Date: December 4, 2020
To: Jenny Raitt; Director of Planning and Community Development
From: Wayne Chouinard, Town Engineer
RE: Plan review for Thorndike Place – Nov 2020

Comments pertaining to the review of the site plan “Thorndike Place Comprehensive Permit”, dated March 13, 2020 and revised November 3, 2020 are as follows:

Sewer System Schematic
(Dorothy Road)

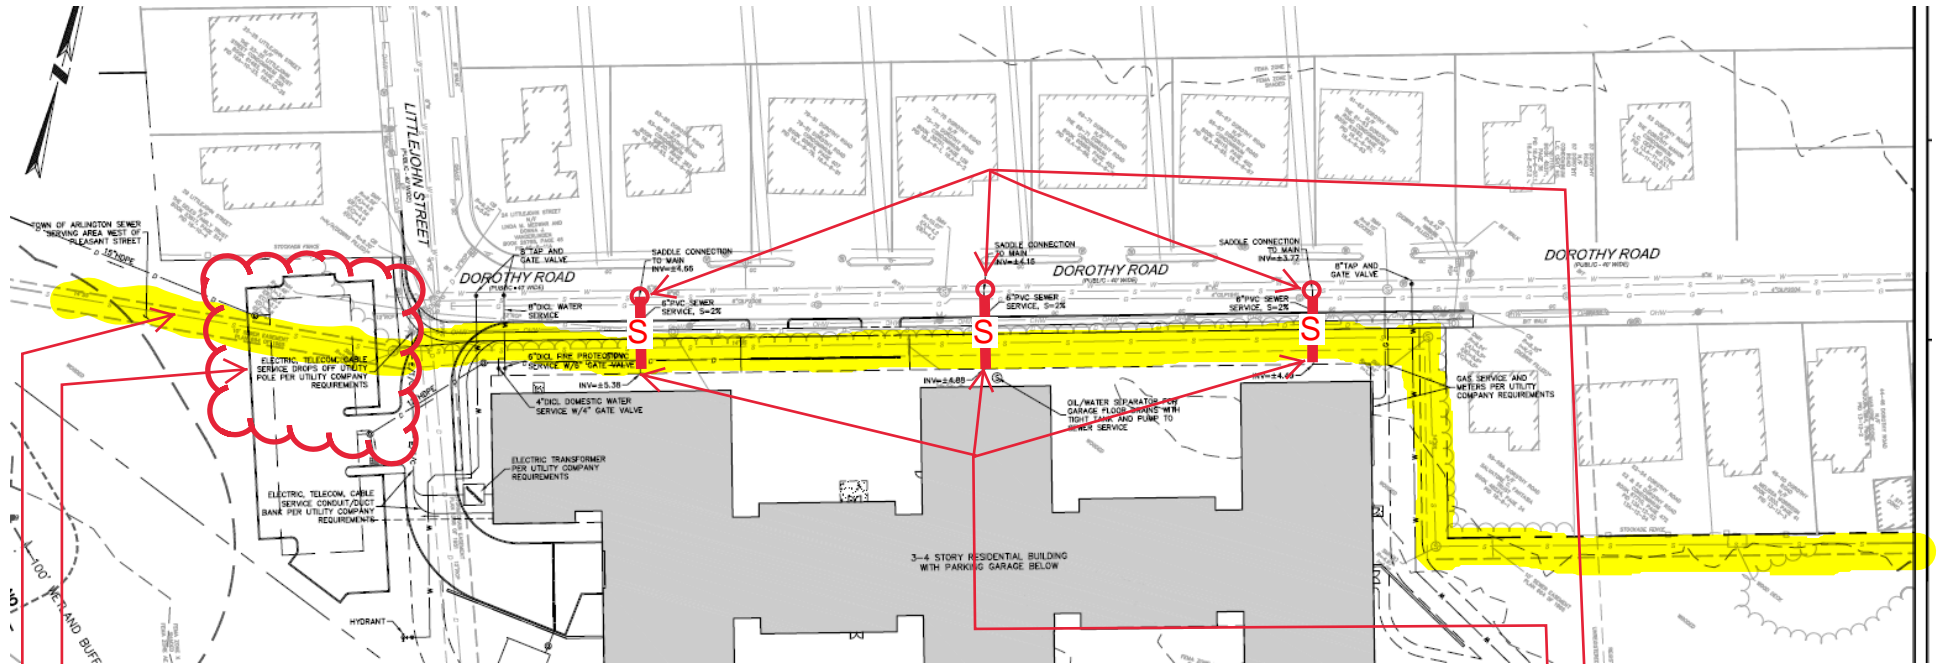
- Due to the anticipated flow leaving the proposed building, sewer services should utilize 8” service lines and are required to discharge into a sewer manhole when entering the Town sewer collection system. (see attached Sewer System Schematic – Dorothy Road)

- Utility Plans indicate connection to the existing sewer line located in Dorothy Road. Any sewer service connection to the Sewer Collection System should use an 8” pvc service. Connections to the main >6” should be directed to a sewer manhole.

Cross Country Sewer Easement
(Dorothy Road)

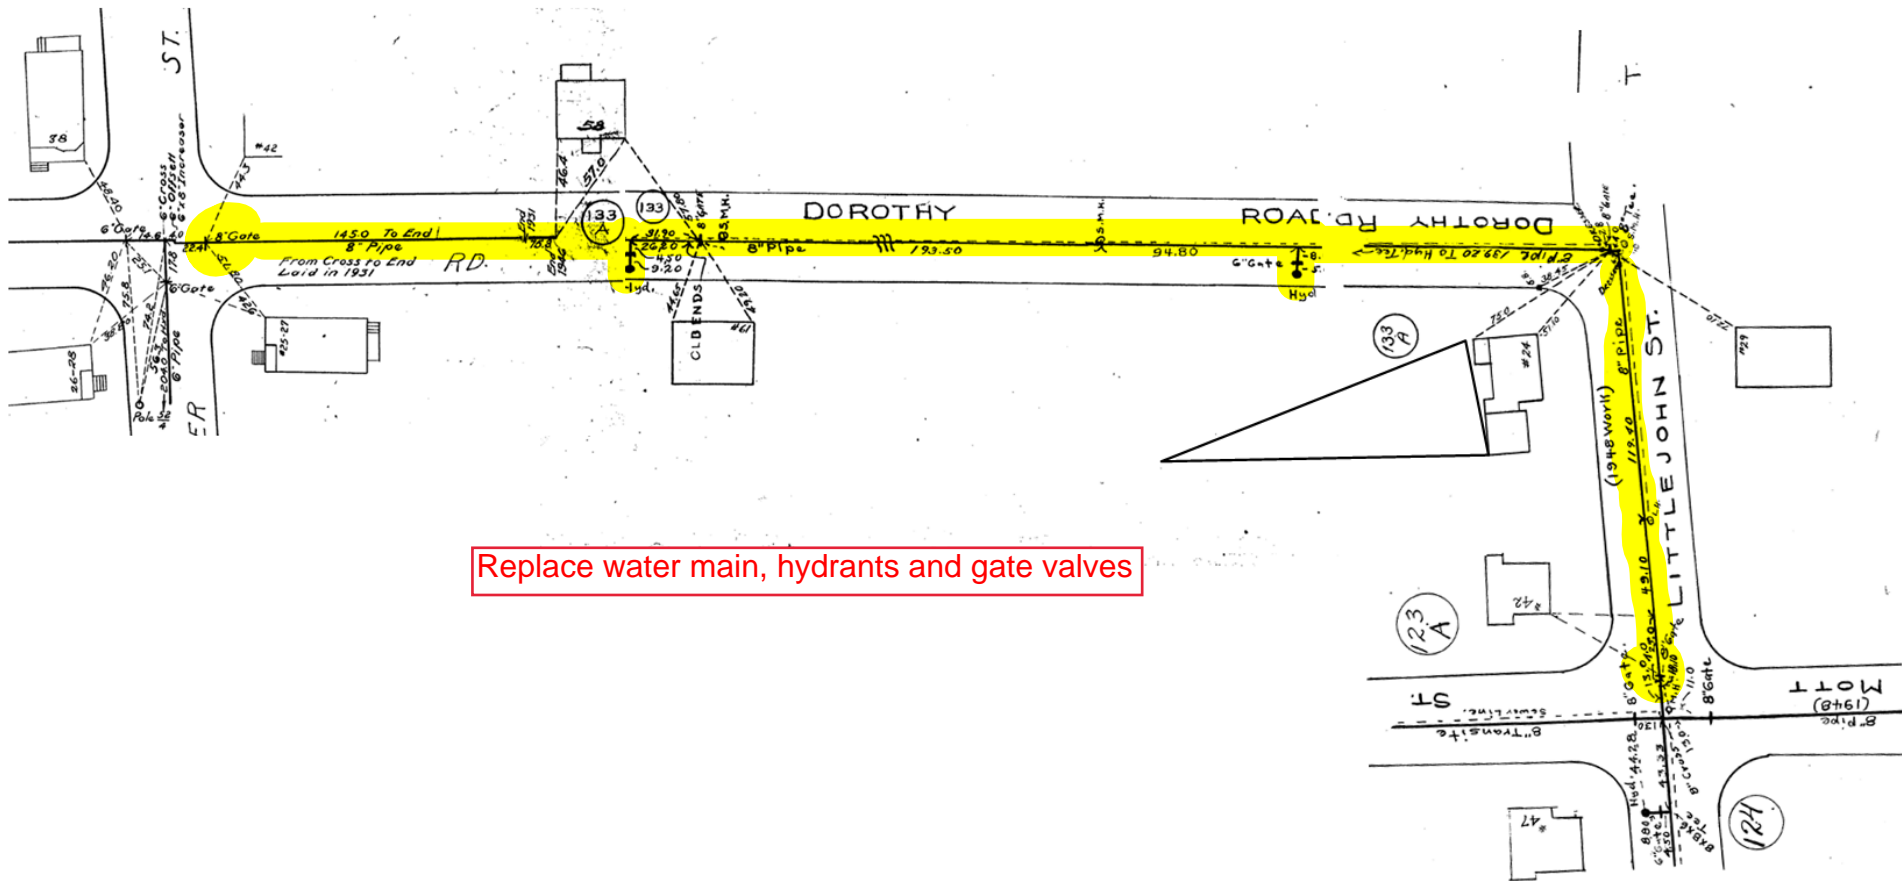
- Stormwater Infiltration Areas shall not be sited above the sewer main/easement or such that the sewer main is within the infiltration zone and/or resulting effects of groundwater mounding.
- Prior to construction a pipe line evaluation shall be performed along the 14/18” sewer main. Upon completion of construction, a post- construction evaluation of the sewer main shall be performed. Any damaged and/or disturbed pipe shall be repaired/replaced.
